City of Berkeley Preliminary Design Review Recommendations List and Responses

Re: Use Permit #: 07-30000100
(ZAB Attachment 5, dated 12-11-08)
Project Name: 1200 Ashby
Project Address: 1200 Ashby Ave
MBH Project No. 48020.3PD

The following are responses to Preliminary Design Review Recommendations dated November 20, 2008.

AGW QUICK FOLD GATE™

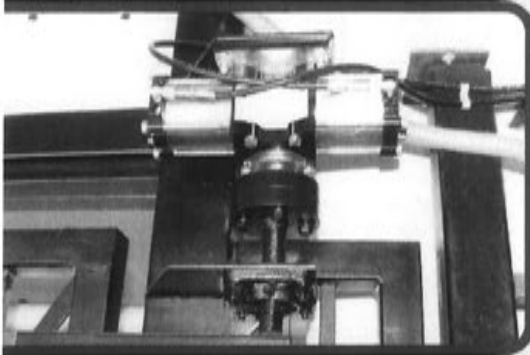
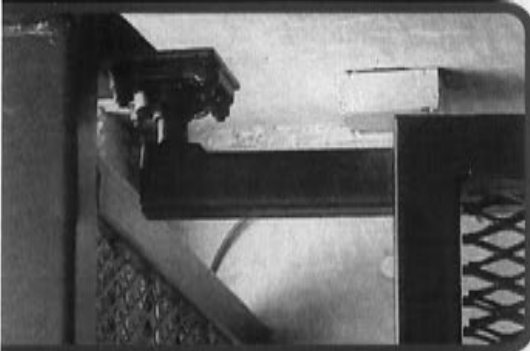
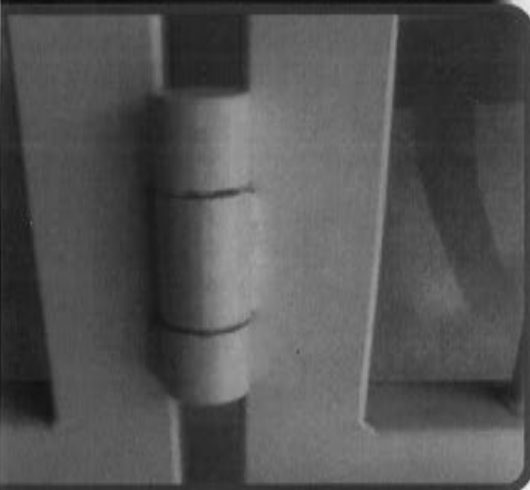
8.	N/A	<p>Recommendation: <i>Provide more detailed design for garage doors at FDR.</i></p> <p>Response: Please see attached product brochure for proposed garage doors.</p>
